River District Design Commission

**AUGUST 8, 2019
4:00 P.M.
FOURTH FLOOR CONFERENCE ROOM**

AGENDA

SkyMeasure™ Roof

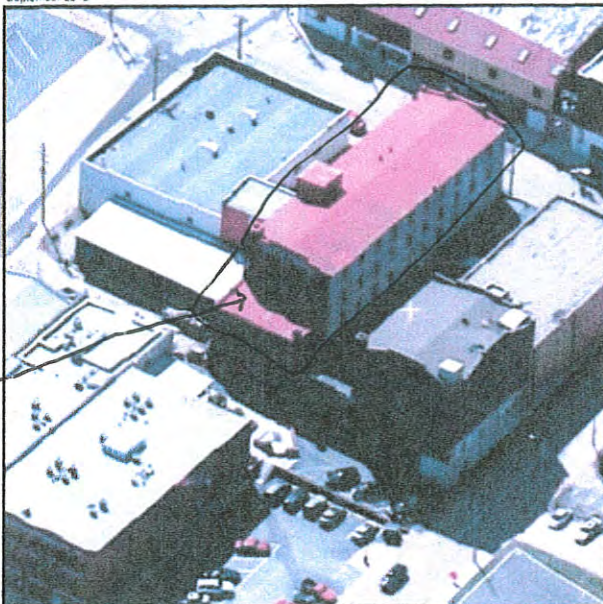
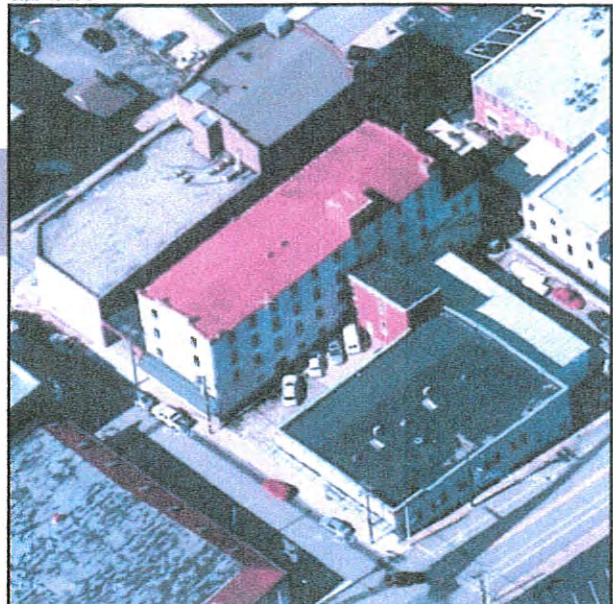
The request contains two components: (1) a black painted façade, and (2) the new black rubber roof. The Guidelines suggest that new paint only be used if a building was previously painted, such as in this case. Additionally, the Guidelines recommend against replacing original components and materials, such as with the proposed roof. However, the Commission is allowed discretion with regards to paint, colors, and alterations to roofs.

Staff recommend the River District Design Commission issue a Certificate of Appropriateness at 315 Lynn Street to paint the exterior brick black (first vote). If the Commission finds the new roof to be satisfactory, staff recommend the Commission vote to recognize the proposal as a minor discrepancy (optional second vote), then vote to issue a Certificate of Appropriateness to replace the red metal roof with a black membrane roof (optional third vote).

TITLE
RIVER DISTRICT DESIGN COMMITTEE SUBMISSION -
ADDITIONAL DECK AND SIGNAGE

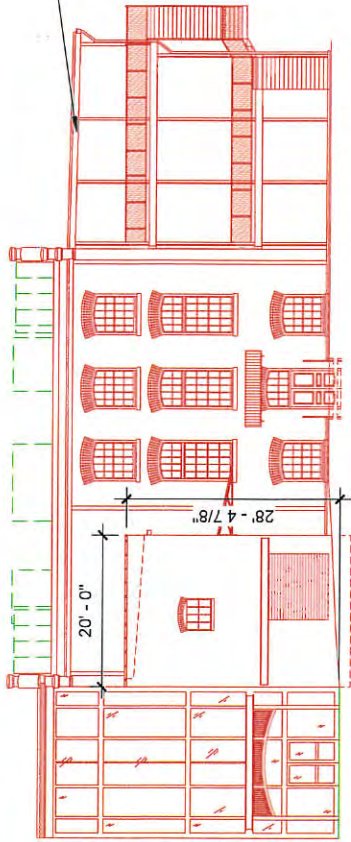
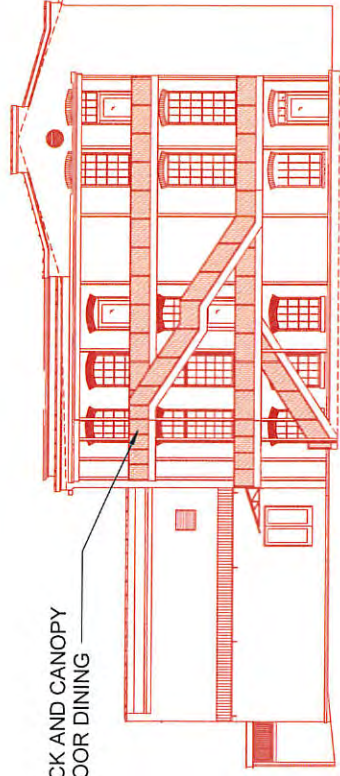
The proposal contains two components: (1) request for deck and roof structure, and (2) request for additional signage. The request for a deck and roof structure provides additional outdoor dining space, compliments the existing outdoor dining, and adheres to the Guidelines. The request for additional signage also adheres to the Guidelines for signage for another restaurant. The applicant presents options for the signage materials to either be steel or paint, both of which are permitted. The existing wall signage is painted on the building.

Staff recommend the River District Design Commission issue a Certificate of Appropriateness at 109 Bridge St., Unit 700 for an addition of a deck and roof structure to the second story of the Riverside Mill building (above Cotton) and additional building mounted signage for wayfinding with the following conditions:

1. The additional deck and roof structure shall not visually interfere with the projecting "Cotton" sign approved on July 11; and
2. The additional signage shall be painted on the building in order to match the existing wall signage.

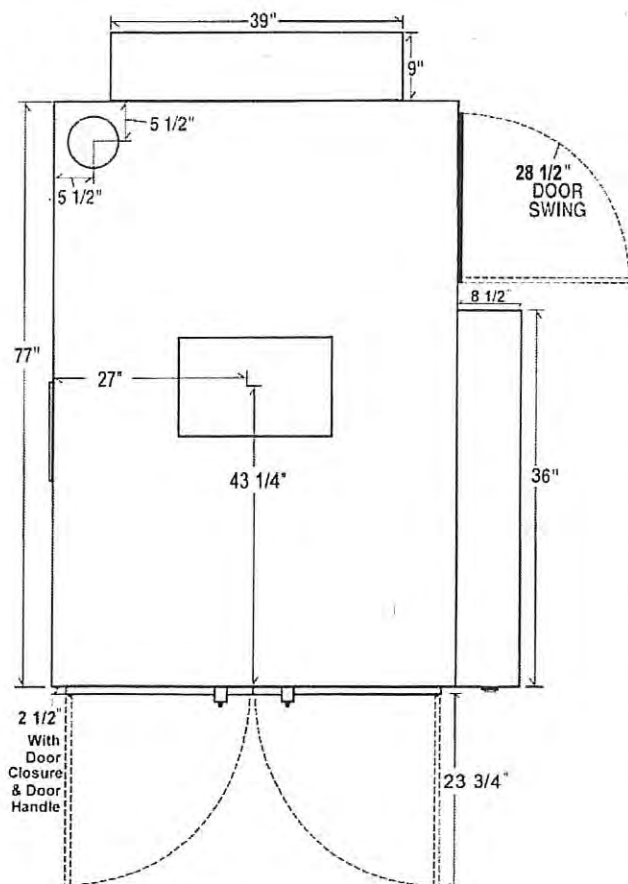
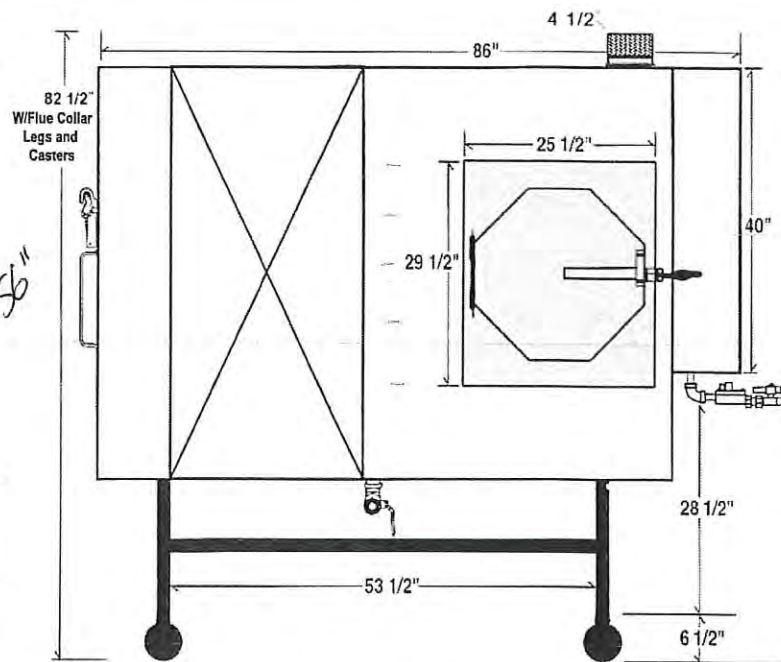
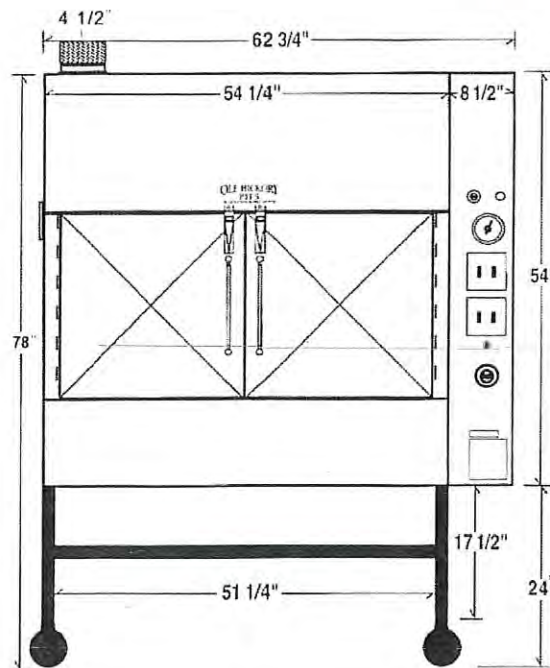
The screening material at 530 Craghead St., Unit 200 was originally considered at the Commission's May 2019 meeting. At that time, the Commission required screening material "to be clad in Trex to act as a screen around the smoker". The Guidelines neither specifically recommend nor prohibit the currently proposed materials (stainless steel or aluminum, or fiberglass reinforced panel) for screening. However, stainless steel and aluminum are recommended materials for other features in the District, such as with signs, and are consistent with the overall design of this particular project.

Previously the RDDC granted a certificate of appropriateness for installation of a smoker at the above address with the condition that the fence and proposed gate in front of the smoker be raised to the full height of the smoker and be "clad in Trex decking" in order to shield the smoker from view. After further consideration we believe that other materials would be better suited for shielding. Due to the nature of Trex decking, i.e. it is heavy and comprised of narrow boards, it will be detrimental to the structural integrity of the gate and may lead to its early failure, whereas a solid panel would be much lighter in weight and actually reinforce the gate. Therefore, we are requesting that the RDDC amend approval of the smoker installation to allow installation of a solid panel such as sheet metal (stainless steel or aluminum) or FRP (fiberglass reinforced panel) on the *inside* of the raised fence and gate, in order to shield the smoker from view. This also would more closely resemble the metal doors attached to the recently constructed dumpster enclosure which is only a few yards away. A sketch is attached which shows the proposed fence and gate to scale, but without this shielding. Another attached measured drawing shows the smoker itself.

Staff recommends the River District Design Commission amend the May 2019 Certificate of Appropriateness for 530 Craghead St., Unit 200 to permit the use of stainless steel or aluminum, in conjunction with the approved fencing, as a screening material around the smoker.

OVERFLOW SCUPPER DETAIL

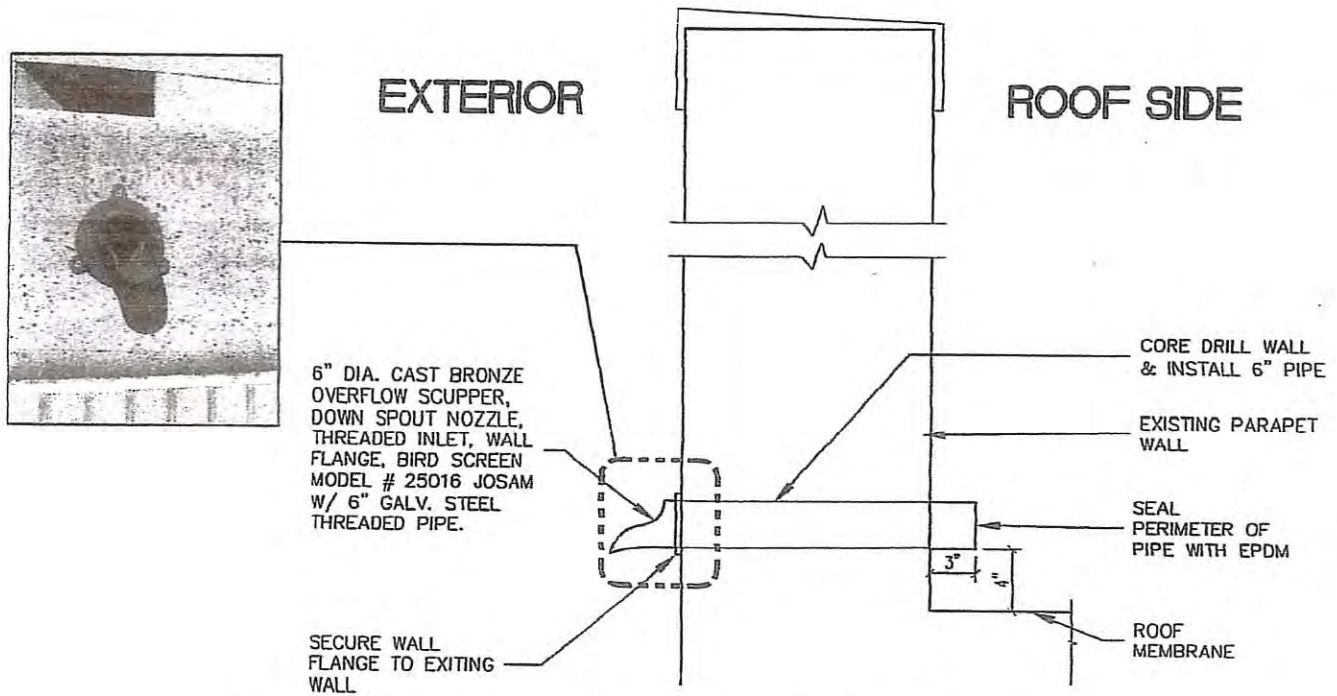
The proposed addition of scuppers (drains) aid the existing roof drainage system, use appropriate materials, and match the character of both the building on 311 Memorial Dr. and other public buildings in the River District. Staff recommends the issuance of a Certificate of Appropriateness at 311 Memorial Dr. to install six (6) overflow roof scuppers.
